Permit No.	Date	Document ID No.
57-03	August 14, 2009	8229

**From:** Mussler, Ed  
**Sent:** Tuesday, August 11, 2009 2:12 PM  
**To:** Gaither, Allen  
**Subject:** FW: Macon County landfill-reduced reuse spray irrigation system  
**Attachments:** image001.jpg; ncdennr-solid waste-permit modification for spray irrigation system.pdf; macon county-overall reuse site plan.pdf

**From:** Mike Waresak [mailto:mikew@mcgillengineers.com]  
**Sent:** Wednesday, August 05, 2009 4:38 PM  
**To:** Mussler, Ed  
**Cc:** Jeff Bishop  
**Subject:** Macon County landfill-reduced reuse spray irrigation system

PLAN  
NOT TO SCALE

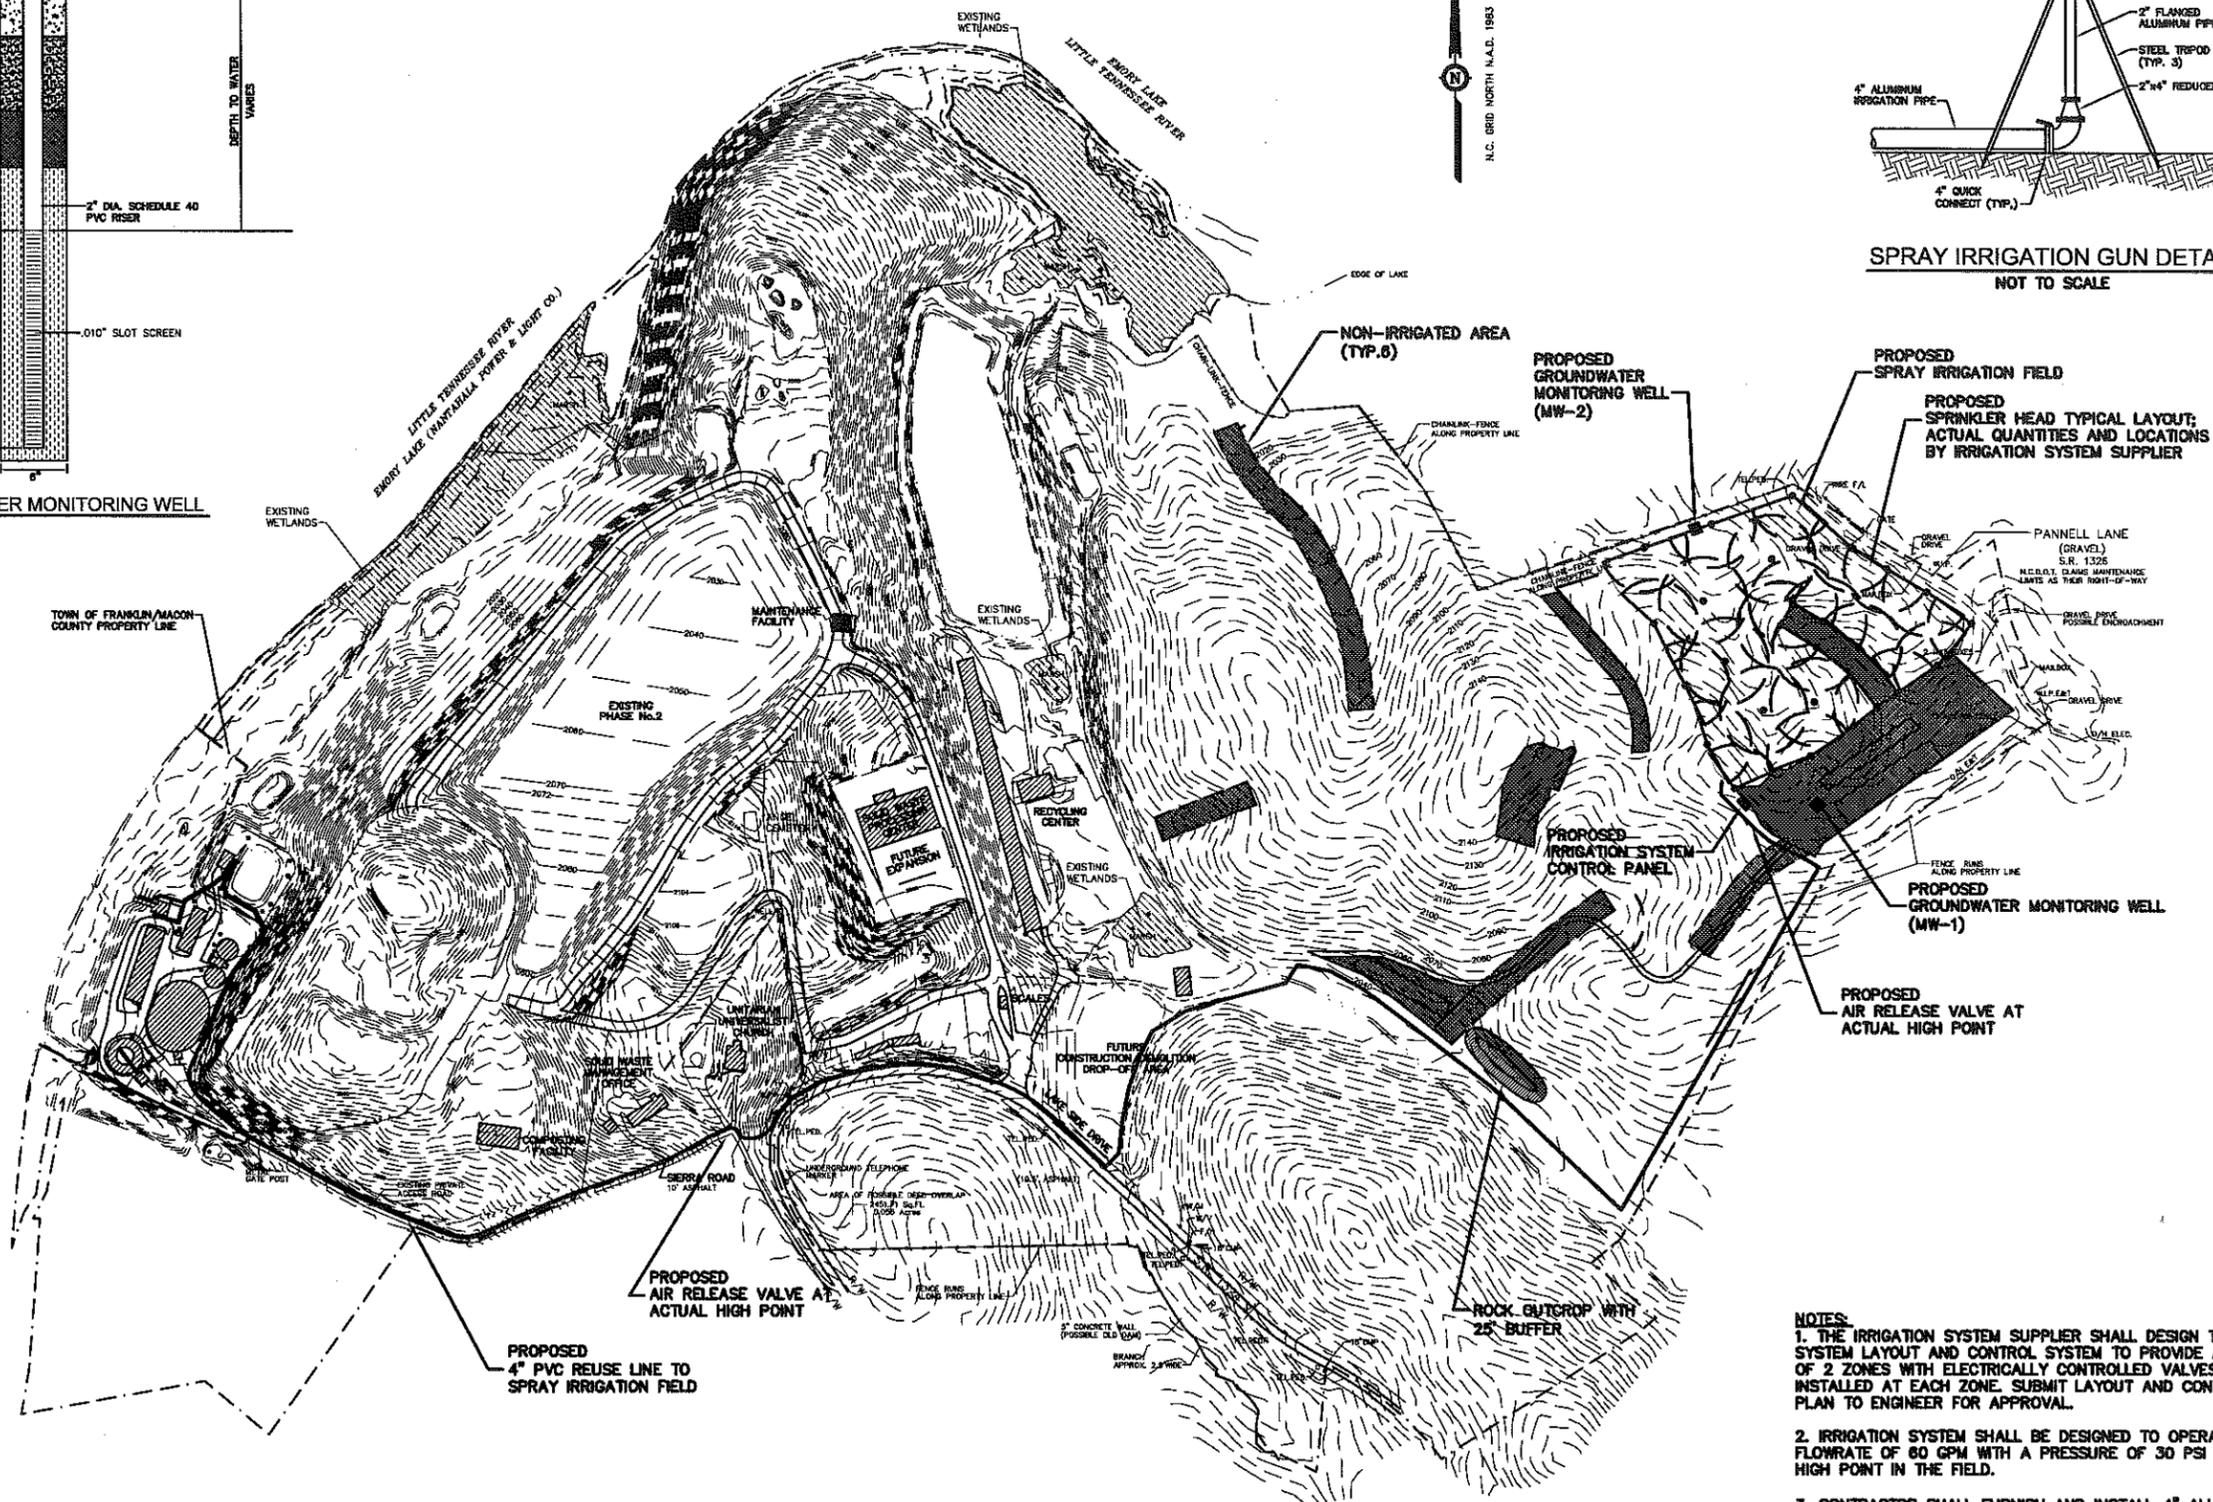
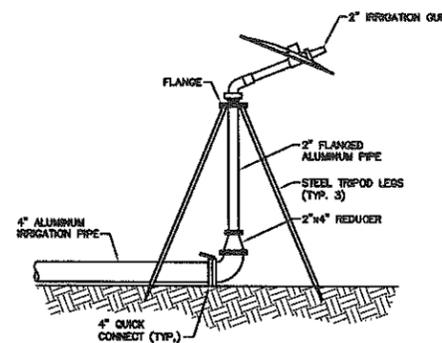
Construction bids for this project were received a couple months ago, and the construction bids exceeded the available funds. Therefore, in order to reduce the cost, we have proposed a significant reduction to the size of the spray irrigation area, reducing the area from approximately 40 acres to approximately 7.22 acres which is within the originally approved area. Attached is a copy of a revised overall site plan showing the reduced irrigation area in the eastern corner of the landfill property. The Division of Water Quality has approved the concept of this reduction, but has requested we obtain written concurrence from your office.

The application rate remains at 1 inch per week, which is consistent with the original proposal. Only the size of the irrigation field has been reduced, for a maximum of approximately 28,000 gpd to be applied over the 7.22 acres when weather conditions permit. The treated wastewater will meet the same reuse water standards as originally submitted using an in-line tertiary filtration system. The contractor has proposed, in order to save cost, to install buried PVC pipe instead of aluminum pipe that was to be installed aboveground. The buried PVC pipe would then be removed when the irrigation system is removed in the future if this area is needed for landfill use.
